Item ID: D350-602-011

Item Name: Heli-Utility-Pod (LH/RH)

TO AMEND INSTALLATION INSTRUCTIONS D350-602 REV E (OR EARLIER REV.)
AND INSTRUCTIONS FOR CONTINUOUS AIRWORTHINESS ICA-D350-602 REV. 0

Dart Heli-Utility-Pods D350-602-011 @ CHG 006 and D350-602-013/-014 @ CHG 002 have new attachment lugs.

FIGURE 1: Aft Crosstube Attachment
(Installation of D4091-1 / D3910-3 Lugs)

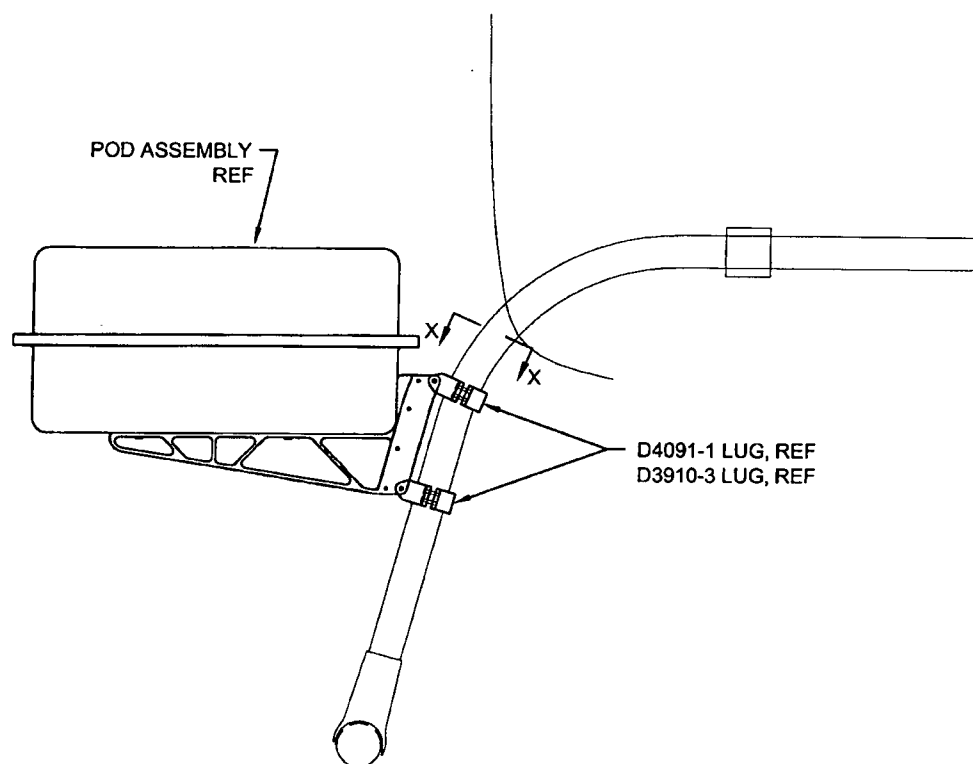
The D2230-1/-3 clamps are replaced with wider D4091-1/D3910-3 lugs. The abrasion strip is replaced with D3984-030 rubber extrusion. The D2462-1700 Neoprene Seal is replaced with D2461-1700 Neoprene 'D' Seal. The modified parts list for Installation Instruction D350-602 and Instructions for Continued Airworthiness ICA-D350-602 is shown on sheet 2 of this service instruction. Install the lugs as shown in Figure 1 & 2 of this service instruction. The pod should otherwise be installed per D350-602 and maintained per ICA-D350-602.

The Dart DSI-9515-011 kit is available to upgrade D350-602-XXX Heli-Utility-Pods made to earlier change numbers with D4091-1 / D3910-3 lugs. The lugs should be installed per Figure 1 & 2 of this service instruction.
